## STAFF REPORT

**TO:** City Council  
**FROM:** Ken Roberts, Planning Director  
**AGENDA ITEM:** **Four Corners 2<sup>nd</sup> Addition** – Preliminary Plat, Preliminary Planned Unit Development (PUD) Plans and Zoning Map Amendment  
**REVIEWED BY:** Jack Griffin, City Engineer  
Ben Prchal, City Planner

To: Ken Roberts, Planner Director	Re: Four Corners 2nd Addition
Cc: Chad Isakson, Assistant City Engineer	Preliminary Plan Engineering Review
From: Jack Griffin, P.E., City Engineer

An engineering review has been completed for the Four Corners 2nd Addition Preliminary Plat/Plans received on January 31, 2019. The submittal consisted of the following documentation:

## PRELIMINARY PLAT

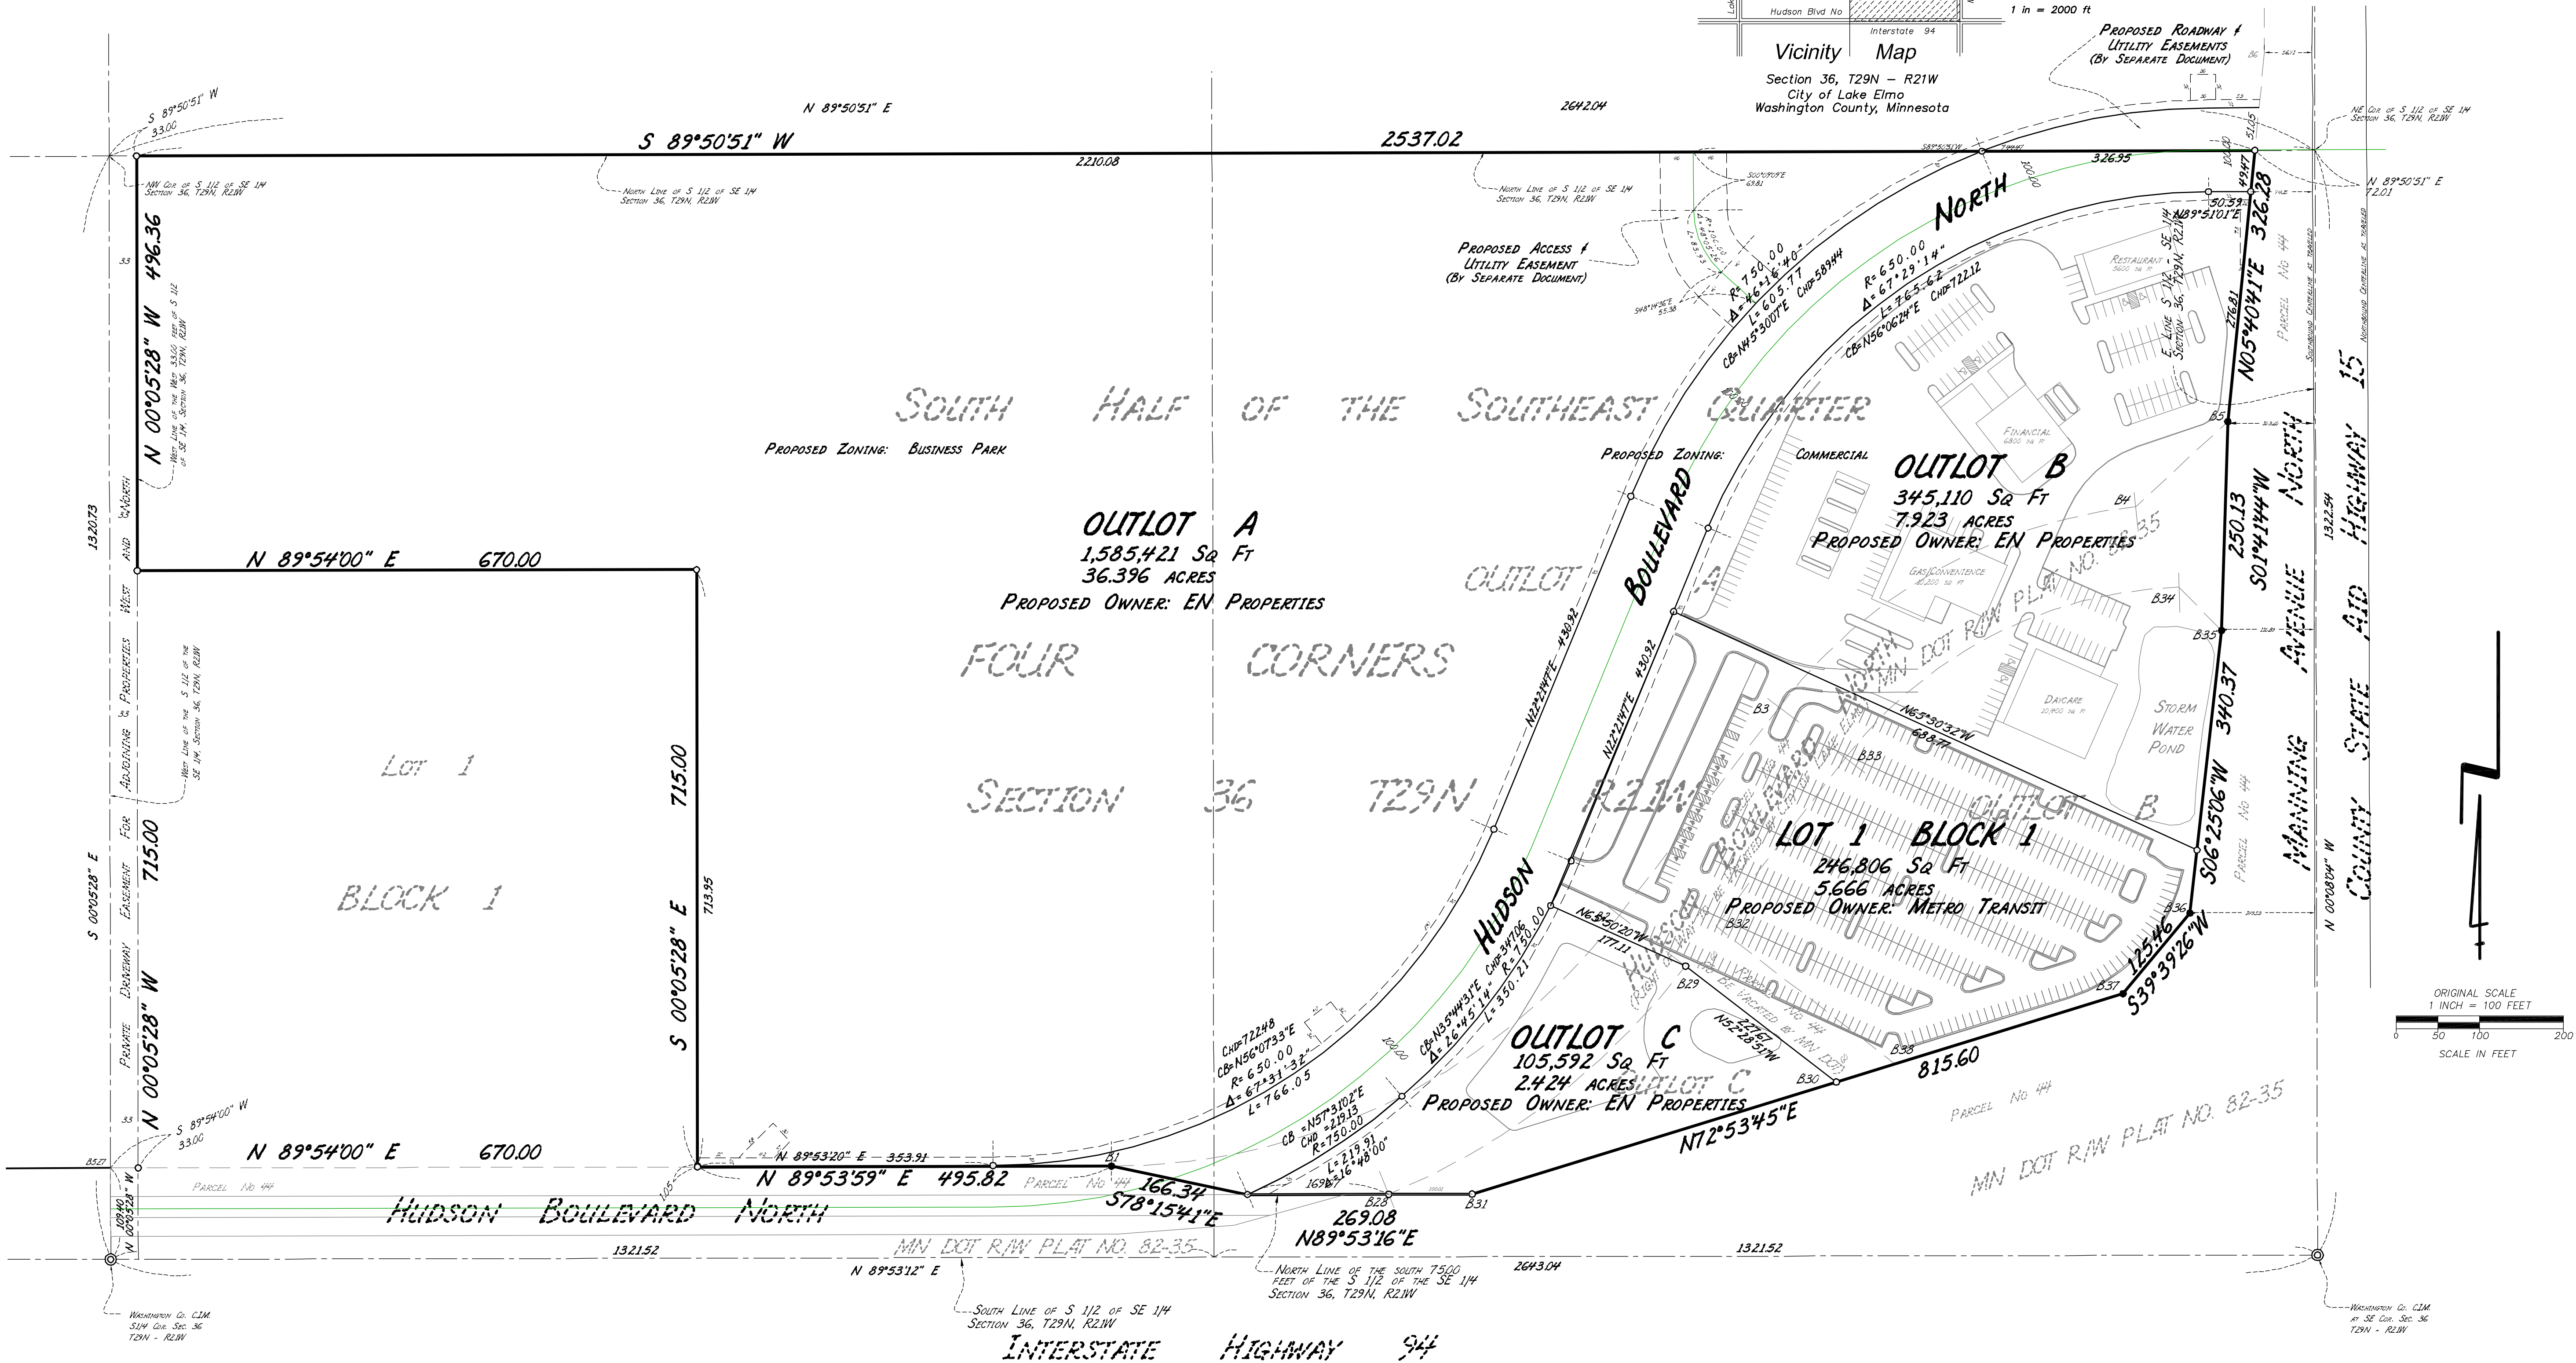
- Outlots A, B, and C are proposed to be owned by EN Properties. Outlots have been labeled on some plans but must also be identified on the street, utility and grading plans.

- A drainage and utility easement must be provided over all of Outlot C. The Outlot C drainage easement will allow for City maintenance of the storm water BMPS and storm sewer system. The drainage and utility easement must be shown on the Preliminary Plat and Preliminary Plans.

- Additional drainage and utility easements must be identified and shown on the Preliminary Plat and Construction Plans (street, utility and grading plans).

- Add drainage and utility easements for the drainage ditch on the north side of Hudson Boulevard.
  - Add drainage and utility easements for the street culvert 100-year HWL.

# GENERAL CONSTRUCTION PHASING NOTES

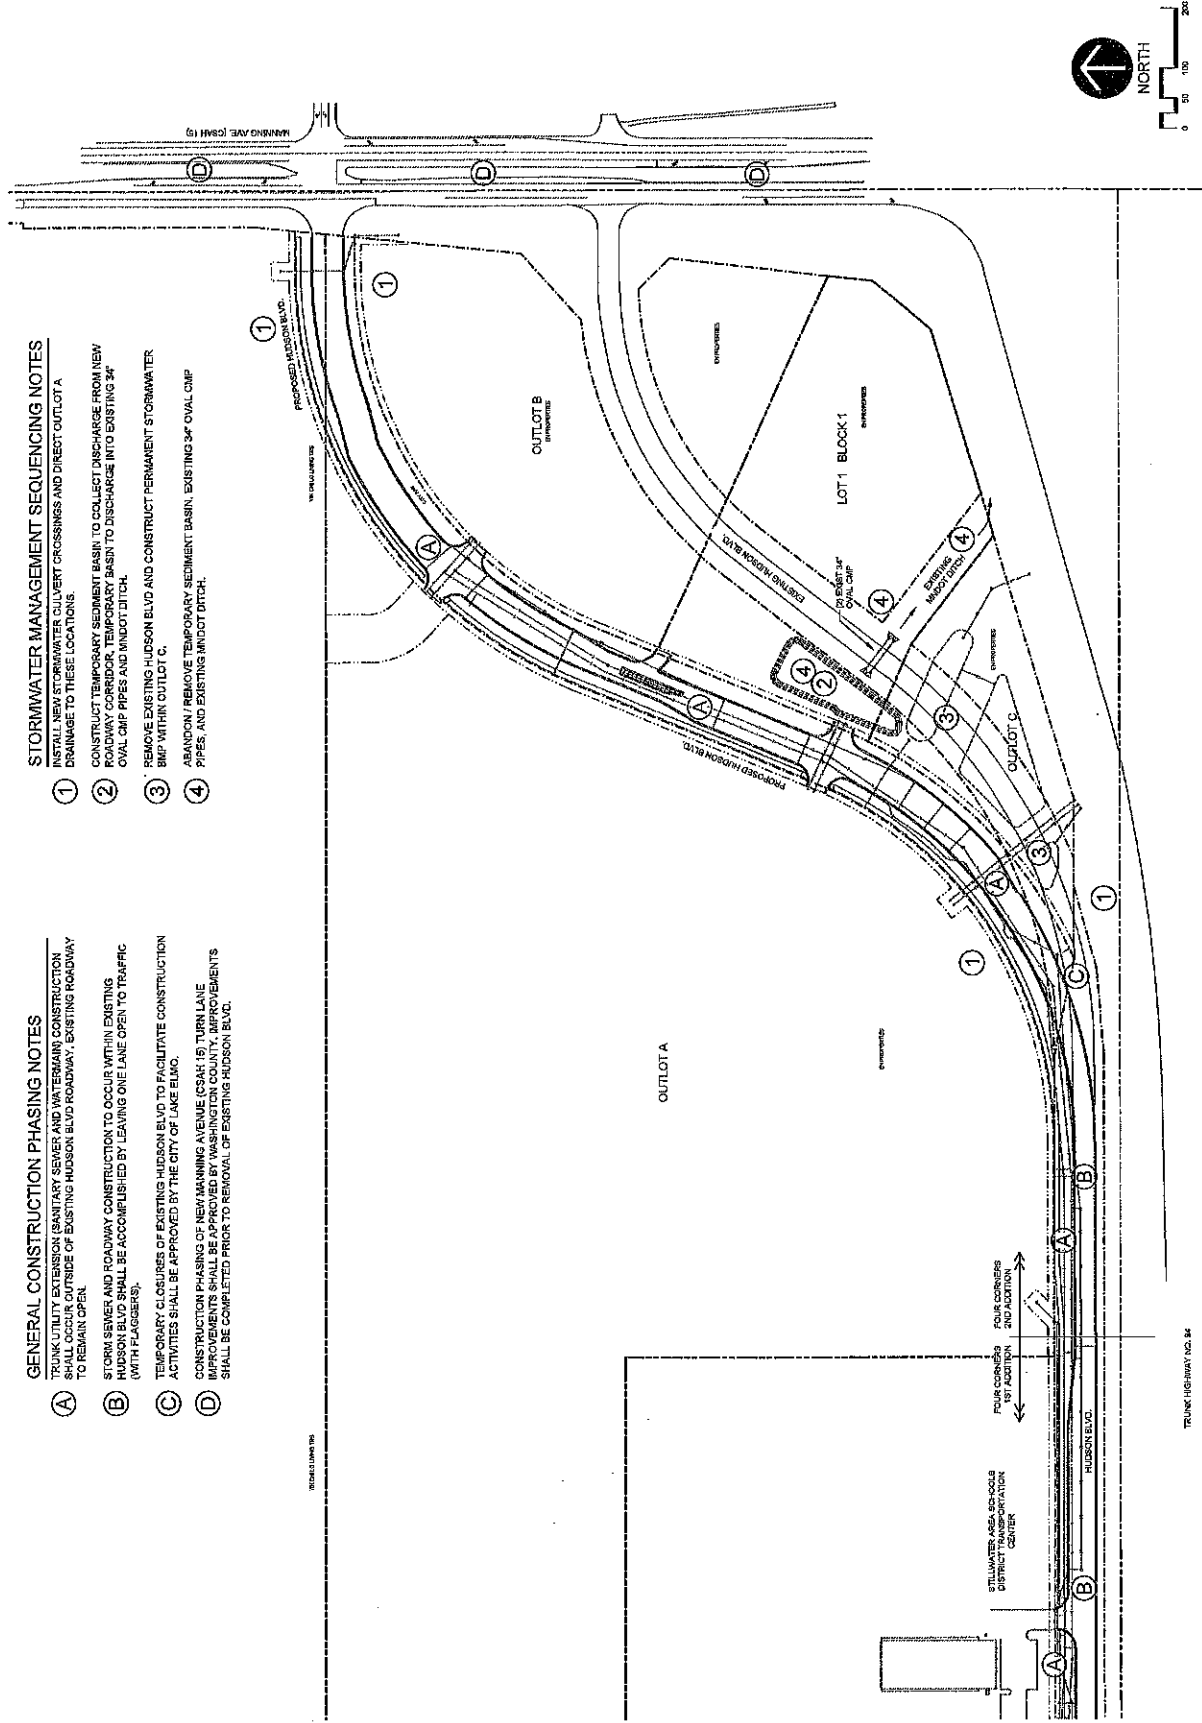
- C0.1. Construction Phasing. The Preliminary Plans must be revised to better detail the construction phasing between street construction and storm water management.
